Subject: MHI's Response to US-APWR DCD RAI No. 307-2336 Revision 1

MHI's Response to US-APWR DCD RAI No. 307-2336 Revision 1

RAI NO.: NO. 307-2336 REVISION 1
SRP SECTION: 15.05.01 – 15.05.02 – INADVERTENT OPERATION OF ECCS AND CHEMICAL AND VOLUME CONTROL SYSTEM MALFUNCTION THAT INCREASES REACTOR COOLANT INVENTORY
APPLICATION SECTION: 15.5.2
DATE OF RAI ISSUE: 4/02/2009

Figure 15.5.2-1.1 Pressurizer Water Volume versus Time with and without LOOP
Chemical and Volume Control System Malfunction that Increases
Reactor Coolant Inventory

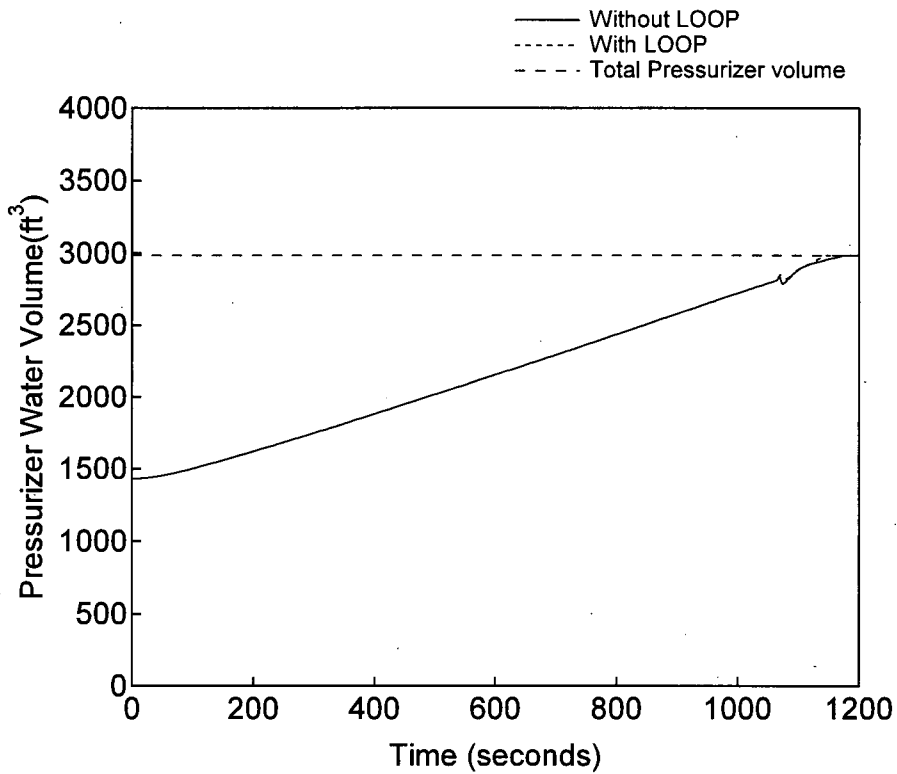
In Section 15.5.2, it is indicated that the reactor is tripped at 1064 seconds. Explain why the turbine does not trip at that time and cause a LOOP? Discuss whether the consequences of this AOO would be different if the analysis assumed a LOOP following reactor and turbine trip?

The intent of the analysis in DCD Subsection 15.5.2 is to determine the amount of time between the occurrence of the high pressurizer water level alarm and the pressurizer filling under the assumption that no operator actions are taken. For the DCD case (i.e. without LOOP), the available time from the high pressurizer water level alarm to the high pressurizer water level reactor trip analytical limit is approximately 11.0 minutes, and the available time from the high pressurizer water level alarm to pressurizer filling is approximately 12.8 minutes.

Table 15.5.2-1.1 and Figure 15.5.2-1.1 below show the results for the case assuming LOOP. For the pressurizer level case, the LOOP (and RCP coastdown) is assumed to occur at the time of the turbine trip (turbine trip is assumed to occur at the same time as reactor trip). This case resulted in the pressurizer filling 30 seconds before the DCD case (i.e. without LOOP), at approximately 12.3 minutes. However, since the operator can terminate this event within 10.5 minutes (10 minutes to recognize the event plus 0.5 minutes to complete the actions to terminate) after the high pressurizer water level alarm, there is sufficient time for the transient to be terminated by operator actions before the pressurizer fills. Therefore, assuming LOOP does not affect the pressurizer filling.

While both the DCD and the sensitivity analysis described in this response do not credit operator actions, the results of both analyses (with and without LOOP) show that the time between the high pressurizer water level alarm and reactor trip is approximately 11.0 minutes. Since operator actions could be credited within 10.5 minutes from the time of the alarm, the event would be terminated prior to the reactor trip and the resultant turbine trip. Therefore, the possibility of LOOP would also be eliminated.

**Figure 15.5.2-3.1 DNBR versus Time
Chemical and Volume Control System Malfunction that Increases
Reactor Coolant Inventory**

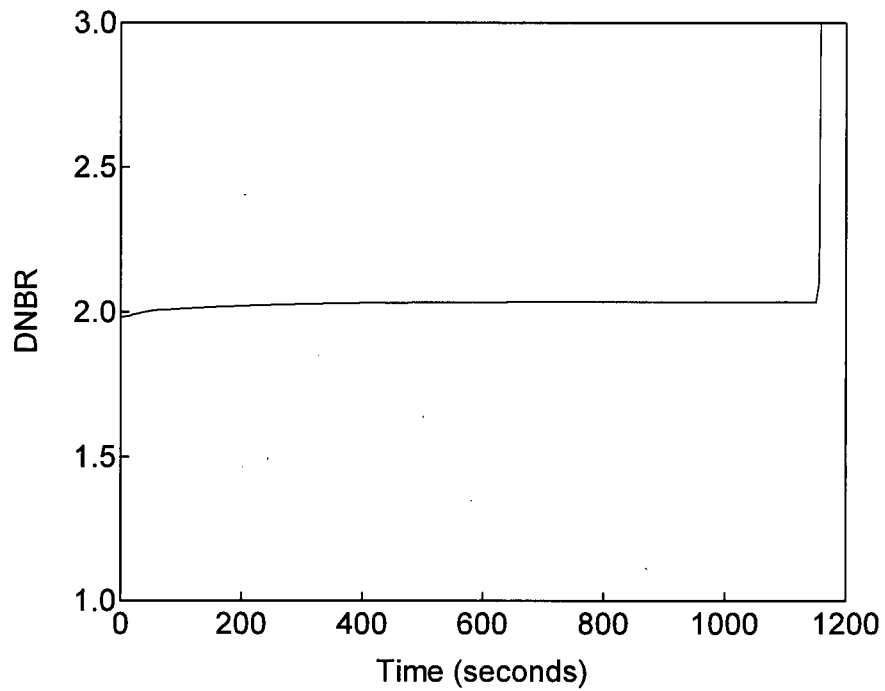
Provide the transient curve for DNBR verses time in the Section 15.5.2 analysis.

The transient curve for DNBR versus time for the DCD Subsection 15.5.2 analysis is shown below in Figure 15.5.2-3.1. The DNBR case shown here uses slightly different initial conditions than the pressurizer level case described in the DCD. The nominal conditions (power, temperature, and pressure) are assumed as the initial conditions for the DNBR case which is analyzed using the revised thermal design procedure (RTDP). This figure confirms that this event is not a DNB limiting event.
